Service Bulletin No: 51-001

ATA Chapter: 51

AIRCRAFT STRUCTURE - GENERAL**DO A CHECK OF THE MATERIAL SPECIFICATION USED DURING MANUFACTURE AND, IF NECESSARY, DO A CHECK FOR CRACKS OR REPLACE THE PART****1. Planning Information****A. Effectivity**

Lower Rudder Bracket - Inspection (If Necessary)
Figure 16

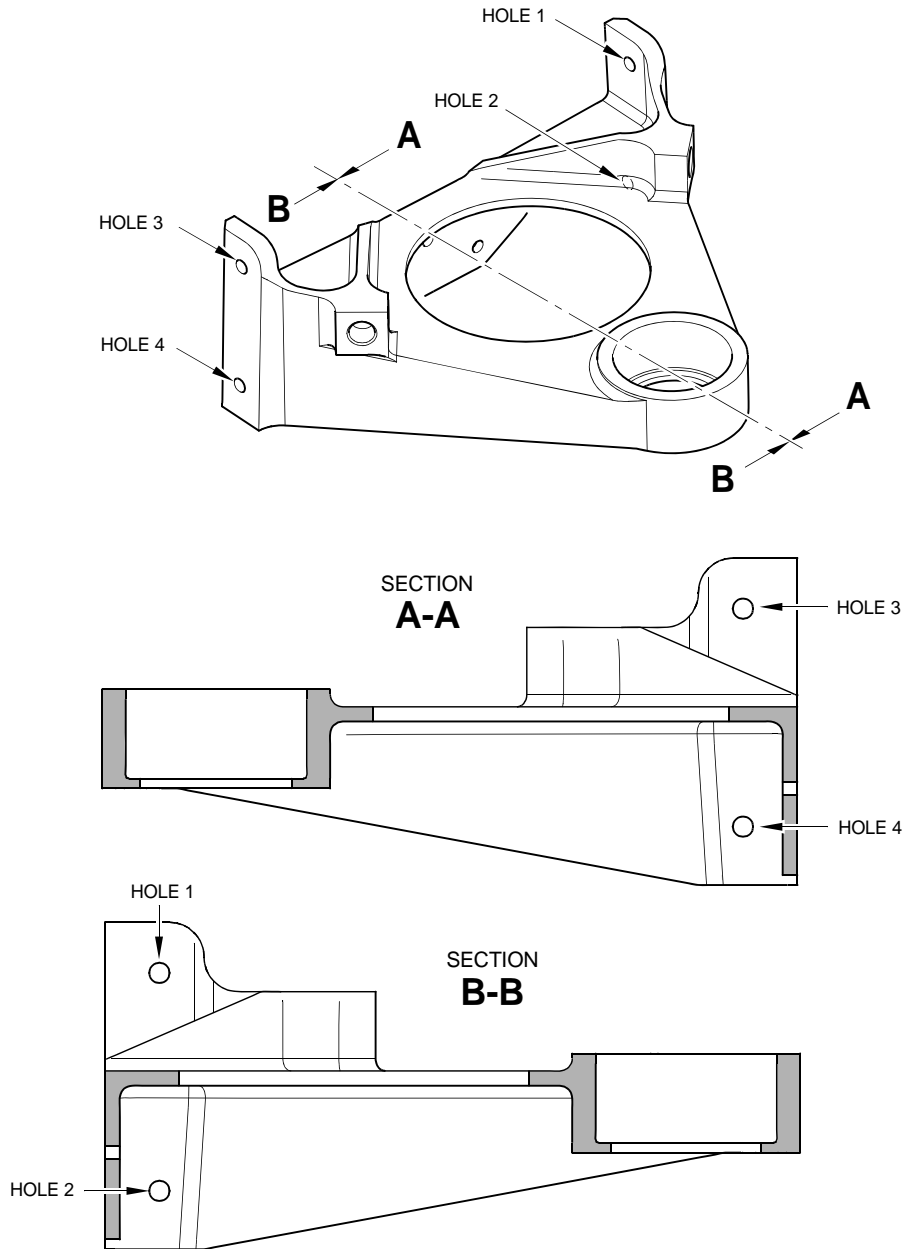
- 2 Remove the nuts (3), the washers (2) and the bolts (1) from the four attachment bolt holes of the rudder lower-hinge-bracket (4).

- 3 Use the absorbent paper (Material No. P02-031) made moist with the solvent (Material No. P01-010) and remove the dirt and grease from the inspection areas of the rudder lower-hinge bearing-bracket.

Left and Right Flap Bearing Support-Bracket - Inspection (If Necessary)
Figure 18

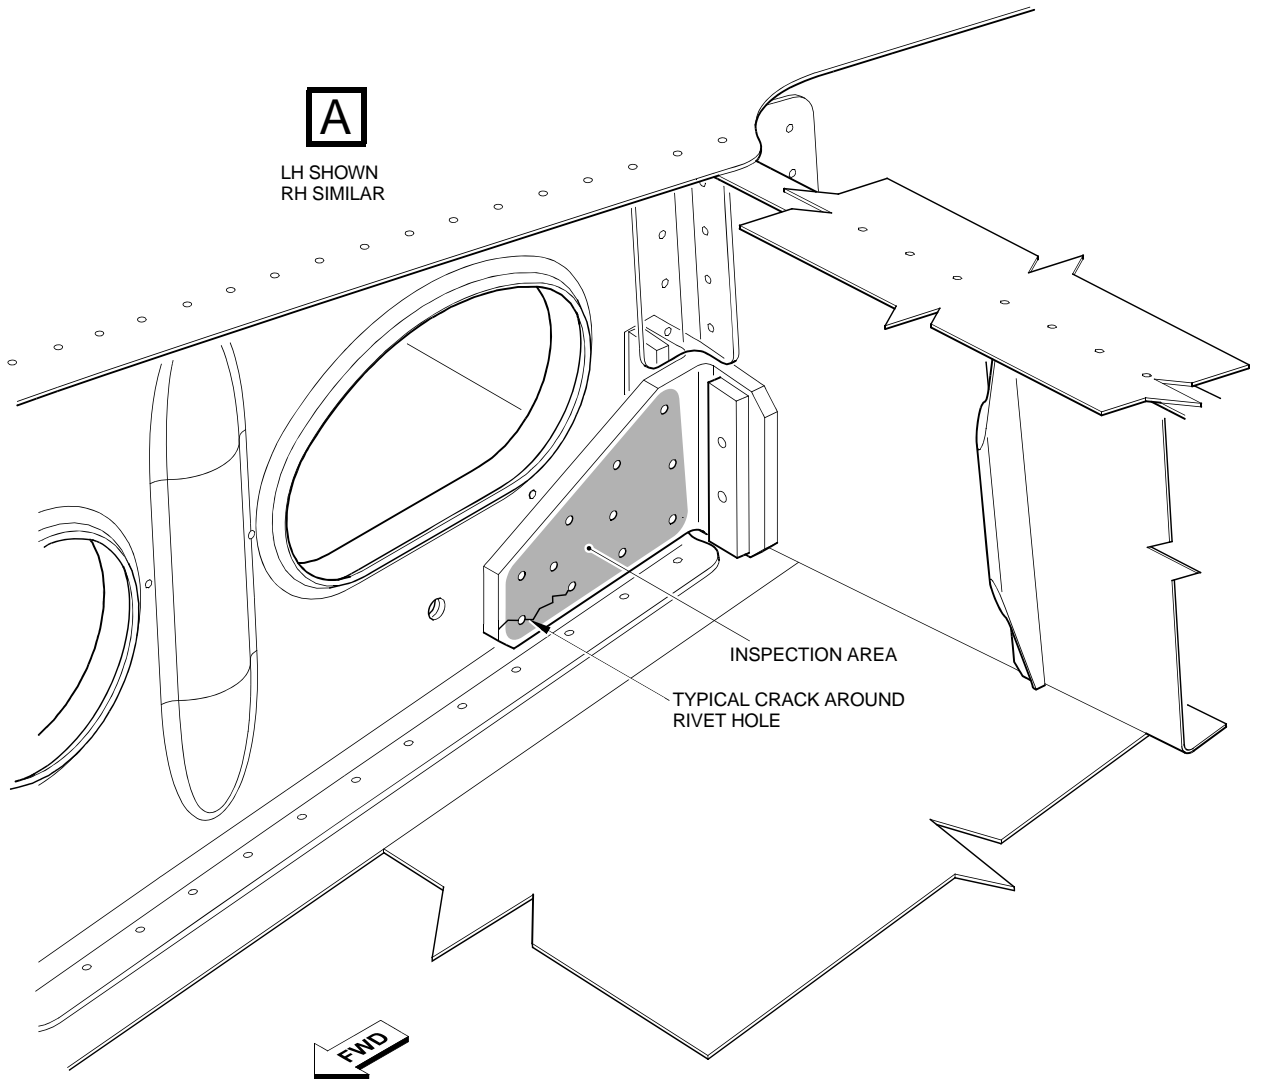
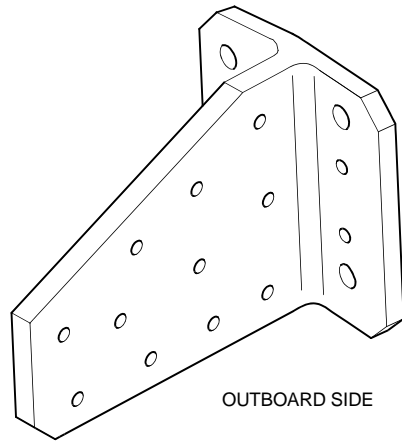
1 Use the absorbent paper (Material No. P02-031) made moist with the solvent (Material No. P01-010) and remove the dirt and grease from the inspection areas of the left flap bearing support-bracket.
